Safety Bulletin

No: SB031

Date: October 9, 2007

Description: OEM 400 HP Motor Lead Wiring

Figure 2 – Sufficient clearance maintained between 600VAC motor connections and junction box enclosure

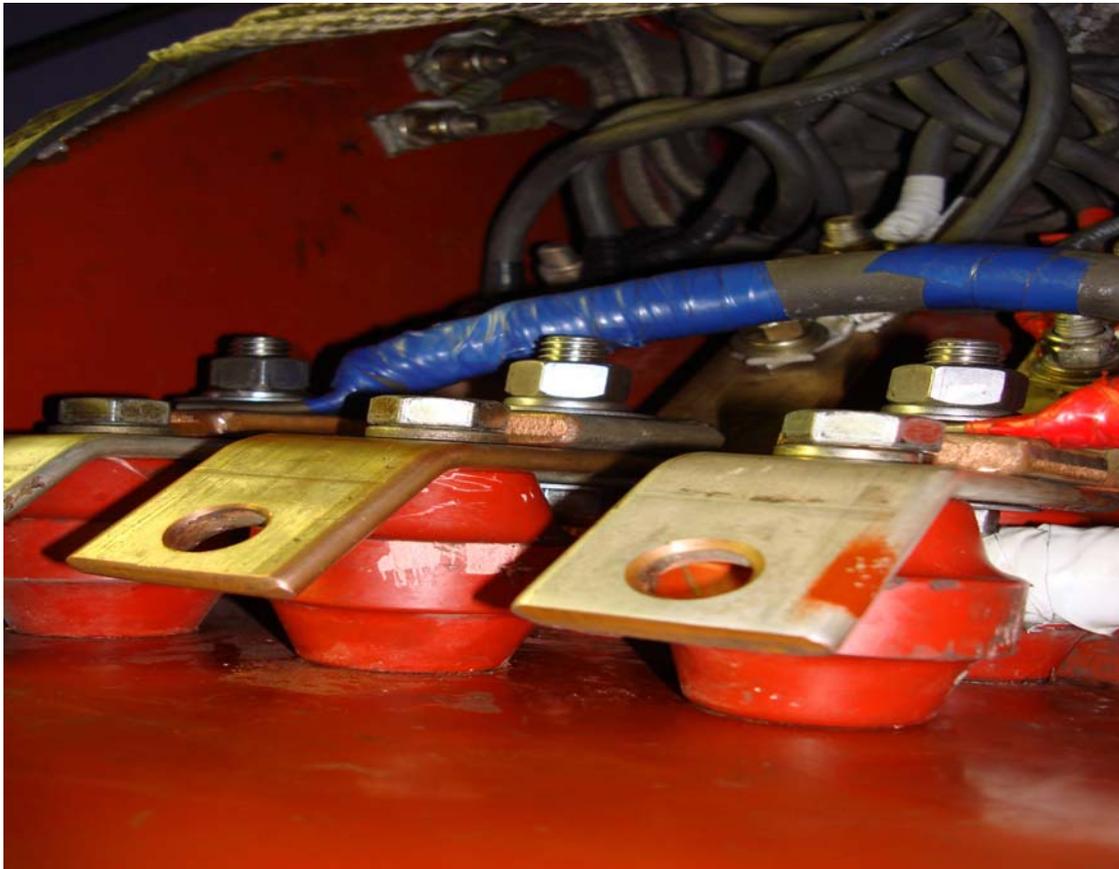
Insufficient clearance between 600VAC motor connections and junction box enclosure:

On 600VAC systems, the Canadian Electrical Code requires a 1" clearance between busbars, including electrical terminations, and any grounded surface. Figure 1 verifies that a minimum of 1" clearance is not maintained between the busbar motor termination bolts and the motor junction box cover.

Figure 2 illustrates how a minimum of 1" clearance between the motor terminations and junction box cover can be maintained by relocating the motor terminations to the center of the busbars.

Figure 5 – Air gap around motor leads entering junction box

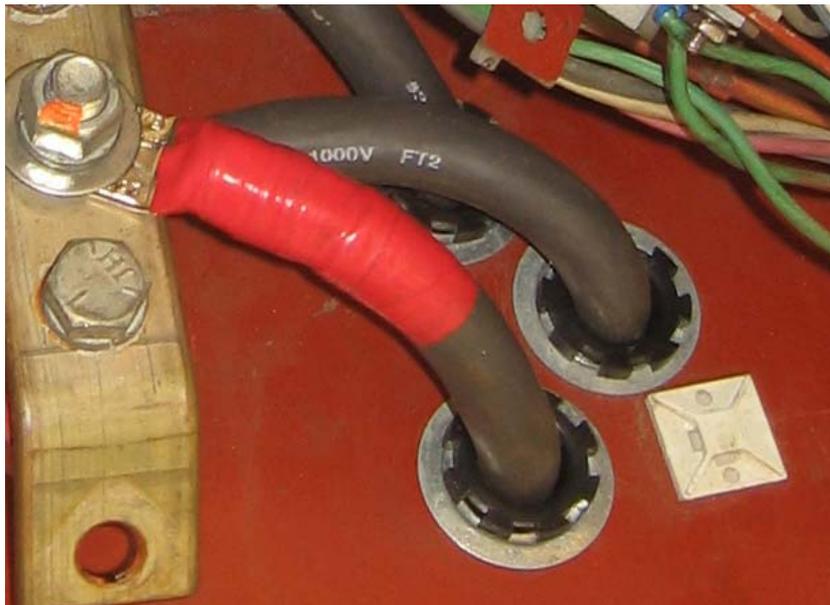
As shown in Figure 5 below, an air gap was found around the motor leads where the leads enter the junction box. This gap must be properly sealed because water, dust, or other debris could enter the junction box and create an electrical hazard.

Figure 6 illustrates the corrective action, which is the installation of cable sealing glands around the motor leads at the entry point, thus eliminating the air gap.
